**CITY OF CENTRAL POINT
PLANNING COMMISSION AGENDA
March 2, 2021 - 6:00 p.m.**

**PUBLIC WORKS OPERATIONS CENTER
SITE PLAN AND ARCHITECTURAL REVIEW**

Consideration of a Site Plan and Architectural Review application for the construction of a public facility that includes a 7,746 square foot 2-story office building, an approximately 15,000 square foot warehouse, parking for equipment and machinery and on-site storage of materials. The 5.12 acre site is located at 235 South Haskell Street within the General Commercial (GC) zoning district in the Transit Oriented Development (TOD) Corridor and is identified on the Jackson County Assessor's Map as 37S 2W 10AD Tax Lots 700 and 798. **Applicant:** Central Point Parks & Public Works Department; **Agent:** S& B James Construction Management

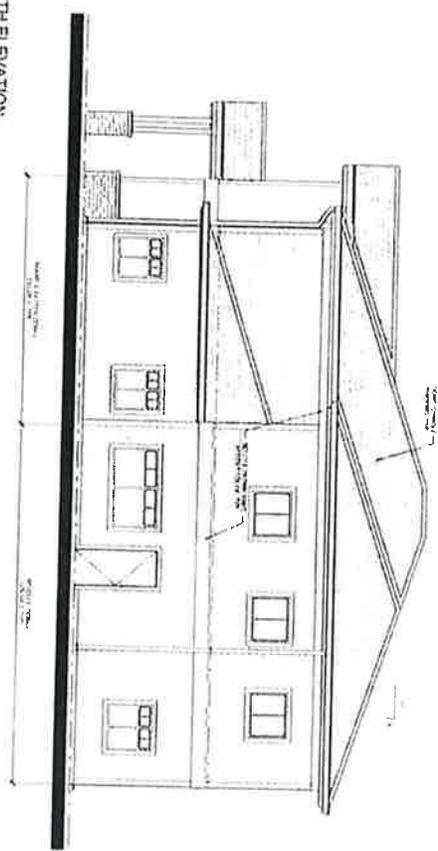
Comment: It will be necessary to relocate or vacate the utility easement to avoid conflicts with the proposed structures. Staff recommends Condition of Approval No. 1(a) requiring documentation of the vacation or relocation of the utility easement prior to building permit issuance.

Comment: Due to the secure nature of the facility, the Applicant has proposed the facility in an accessible location for Rogue Disposal. This portion of the Ash Street right-of-way is not currently developed and is not planned to be utilized for any other purpose. To comply with the standard in CPMC 12.20.020(A)(1), the City will need to vacate the unused portion of the right-of-way or find a suitable location outside the security fence for the facility. Staff recommends Condition of Approval No. 1(b) requiring that the unused portion of the Ash Street right-of-way be vacated and incorporated into project site or provide a revised site plan that depicts the proposed trash enclosure on the project site and outside of the public right-of-way of Ash Street.

Comment: In accordance with CPMC 12.36.100(C), street trees must be installed at a minimum of 40-feet between the centers of the trees. The frontage along the west property boundary requires a minimum of 19 street trees and the frontage along the north property line requires a minimum of six (6) street trees. Parking area perimeter requirements are identified in Table 17.75.03, CPMC 17.75.039(G). The parking area along South Haskell Street requires five (5) trees and 24 shrubs. Staff recommends Condition of Approval No. 1(c) requiring submittal of a landscape and irrigation plan demonstrating compliance with design and landscape requirements before building permits are issued.

1. Prior to building permit issuance, the applicant shall:
 - a. Provide documentation that demonstrates the 20-foot utility easement, bisecting Tax Lot 700 east-to-west, is vacated or relocated to avoid conflicts with proposed structures.

- b. Provide a revised site plan that depicts the location of the proposed trash enclosure entirely on the subject property and outside of the public right-of-way; or initiate a right-of-way vacation of the unused portion of Ash Street. The right-of-way vacation shall be complete prior to final inspection and certificate of occupancy.

- c. Provide a landscape and irrigation plan that demonstrates compliance with frontage and parking facility landscape requirements, including a minimum of 19 street trees along South Haskell, a minimum of six (6) street trees along Ash Street and a minimum of five (5) trees and 24 shrubs along the perimeter of the parking area facing South Haskell Street.
